Technical Service Bulletin

CRACK ON FRONT SHOCK ABSORBER DUST BOOT

Bulletin No.: 02-013/18

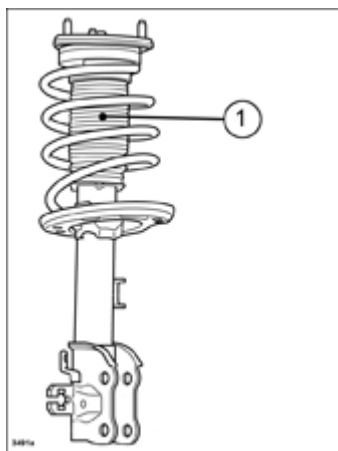
Some vehicles may exhibit a crack on the front shock absorber dust boot (1). This may be caused by the dust boot having insufficient resistance to the cold. The shape and material of the dust boot has been changed to improve its resistance to cold.

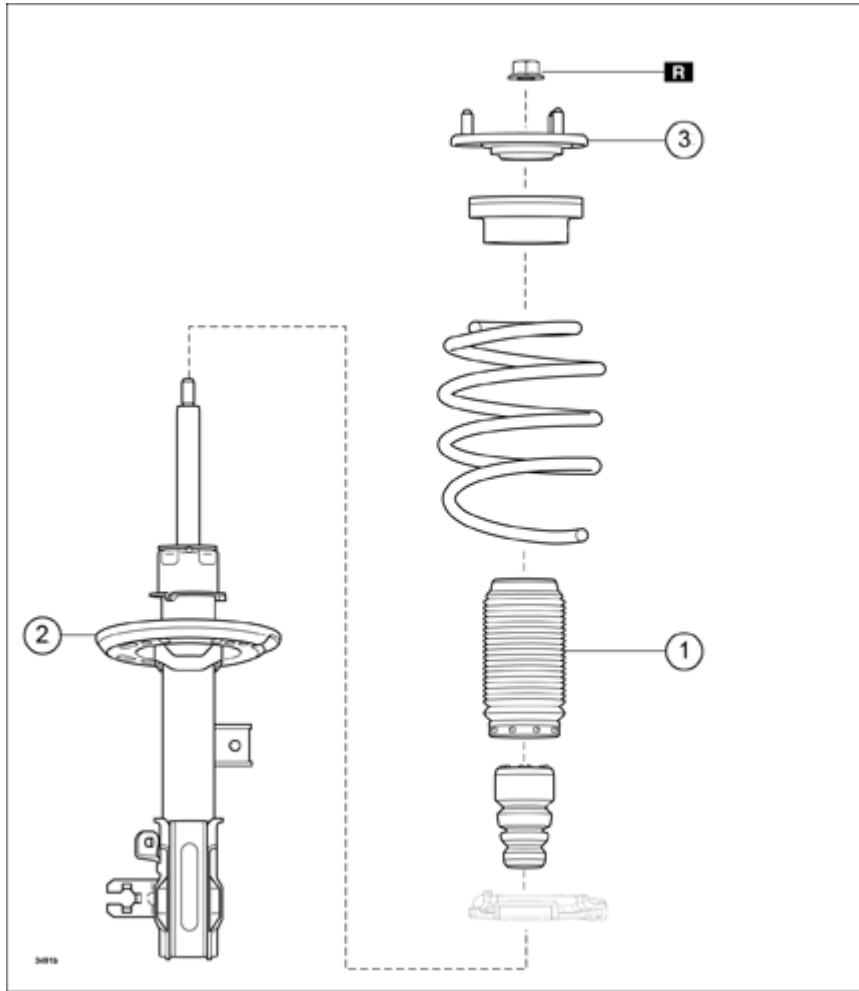
1. Verify customer concern.
2. Replace the dust boot (1) according to the instructions on MGSS online:

- Only replace the affected side(s).
- Before removing the mounting rubber (3), put a position mark on the mounting rubber so it can be installed back in its original position.

CAUTION: It is not necessary to adjust the front wheel alignment because the front shock absorber (2) and the mounting rubber (3) are not replaced. However, make sure to install the mounting rubber to the original position.
